UNTIL SUCH TIME AS THESE DRAWINGS ARE APPROVED BY THE APPROPRIATE REVIEWING AGENCIES, JR ENGINEERING APPROVES THEIR USES DESIGNATED BY WRITTEN AUTHORIZATION.	PREPARED FOR <b>SR LAND, LLC</b> 20 BOULDER CRESCENT SUITE 201 COLORADO SPRINGS, CO 80903 JAMES F. MORLEY (719) 471-1742
	<b>J.R. ENGINEERING</b> A Westman Company  Centennial 303-740-9888 • Colorado Springs 719-583-2583 Fort Collins 970-491-9888 • www.jrengineering.com
BY: _____ DATE: _____ No. REVISION: _____ H-SCALE 1"=30' V-SCALE 1"=3' DATE 05/04/23 DESIGNED BY MMC DRAWN BY MMC CHECKED BY _____	STERLING RANCH ROAD & BRIARGATE PARKWAY STORM PLANS STORM SEWER PLAN & PROFILE SHEET 3 OF 19 JOB NO. 25188.03

STERLING RANCH ROAD & BRIARGATE PARKWAY STORM PLANS

STORM SEWER PLAN & PROFILE

# v5\_CDs Storm.pdf Markup Summary

DP11 PROFILE  
STA 10+00.00 TO 17+36.48  
PUBLIC

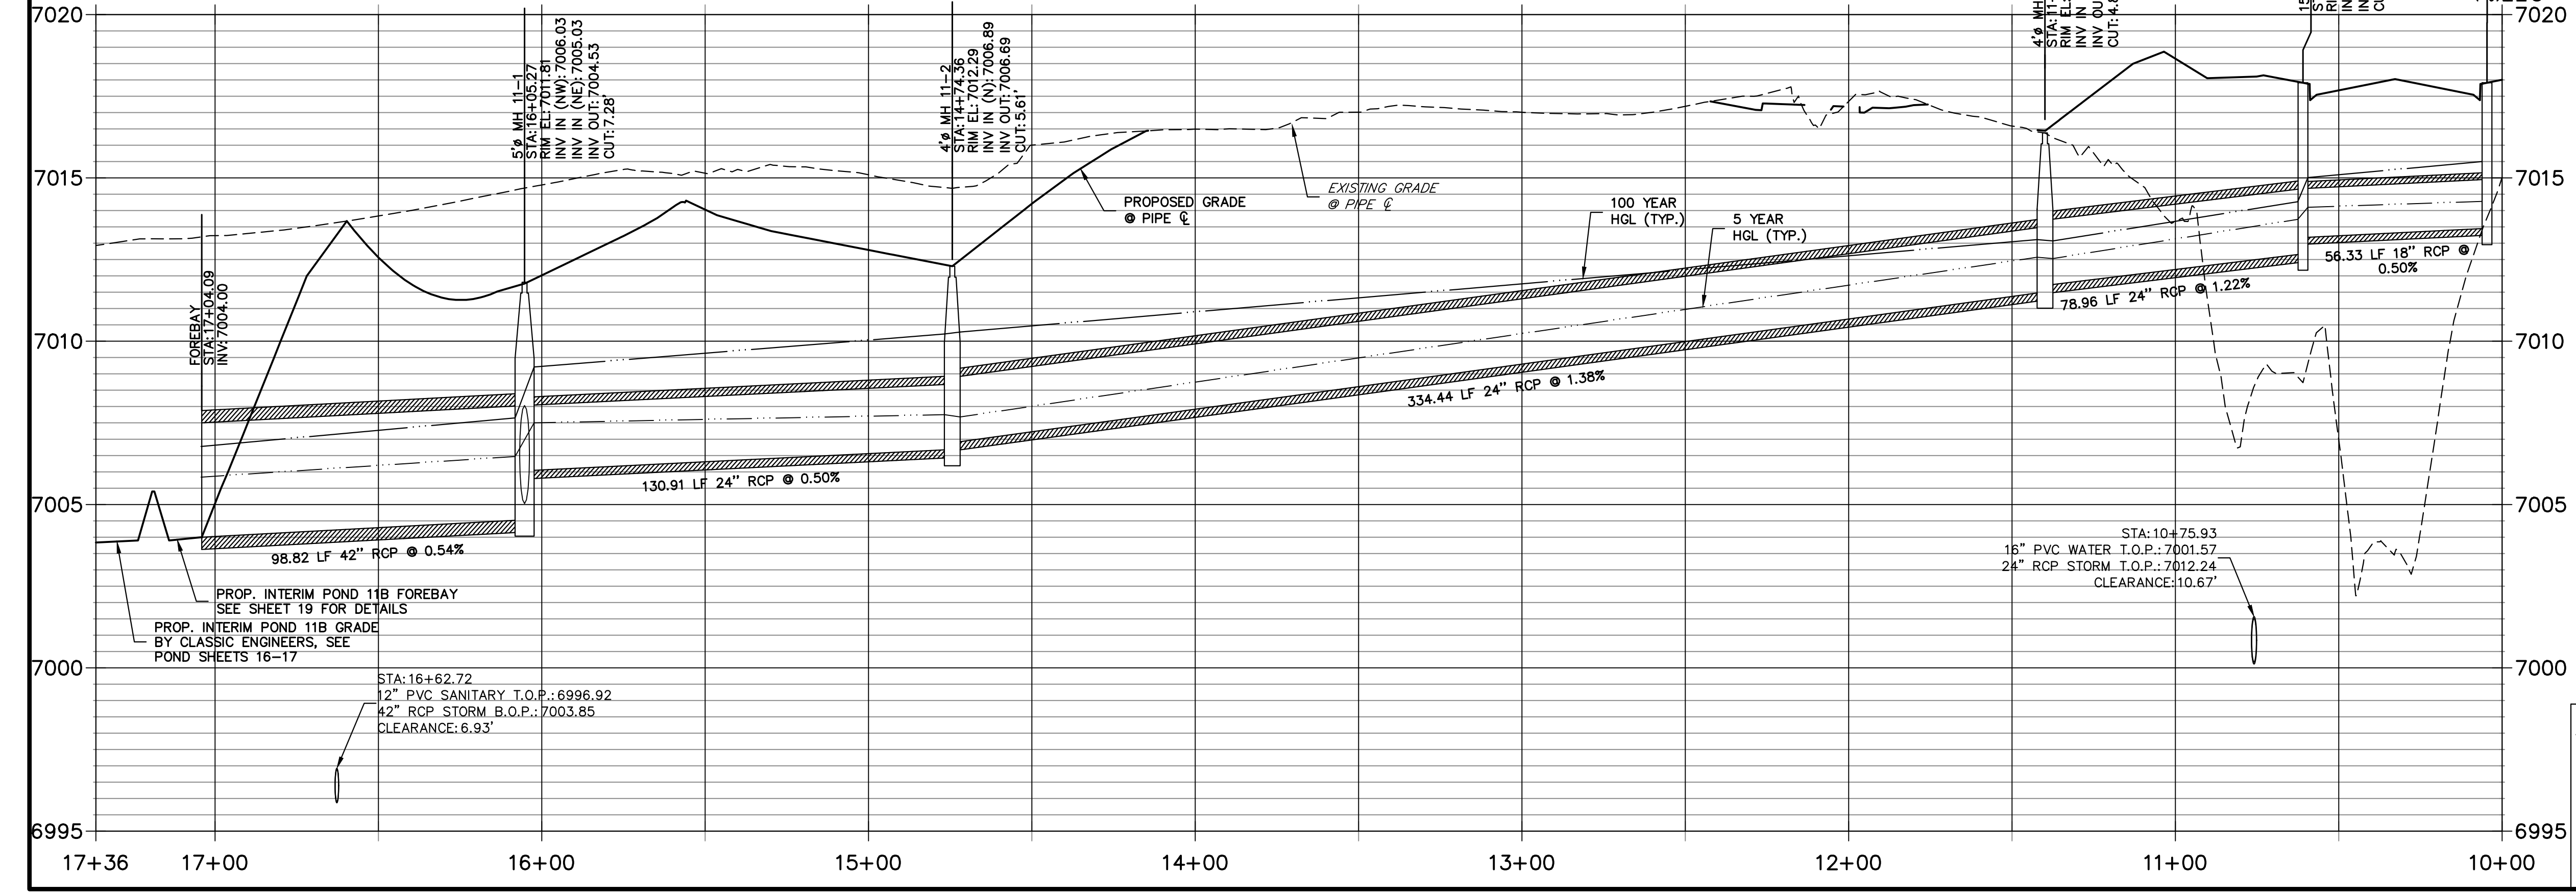
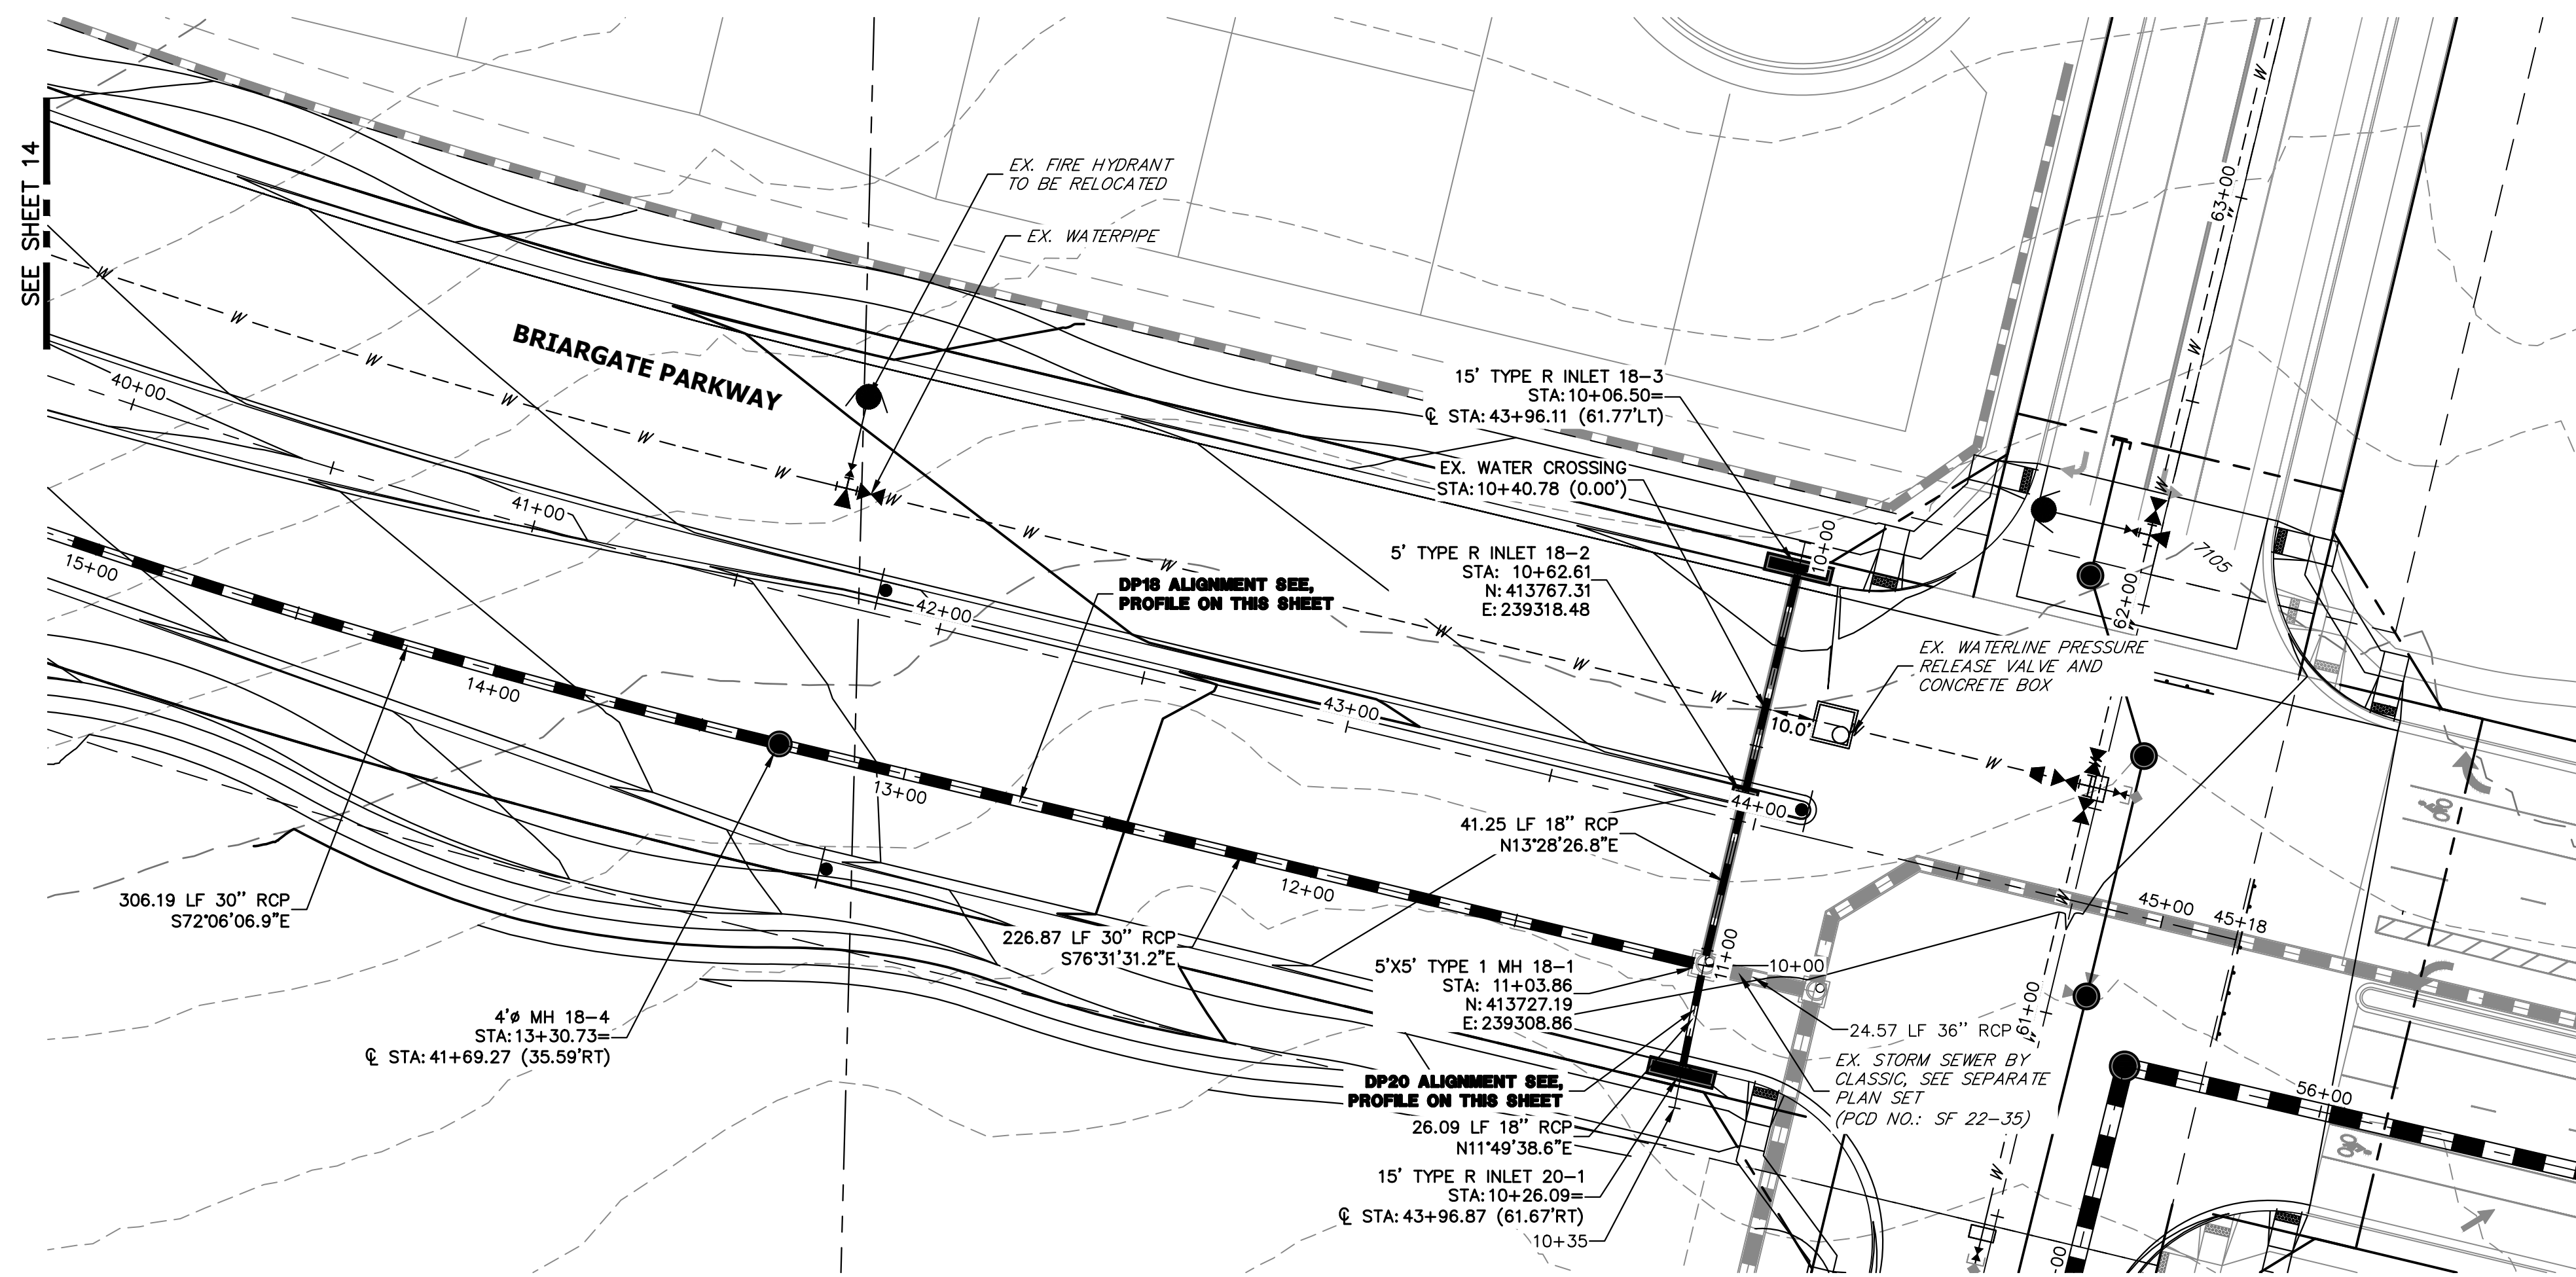
Unresolved:  
This pipe should also be class 4, as it's located within Briargate Pkwy

Label Tract/Lots -  
Are any easements needed for storm pipes?
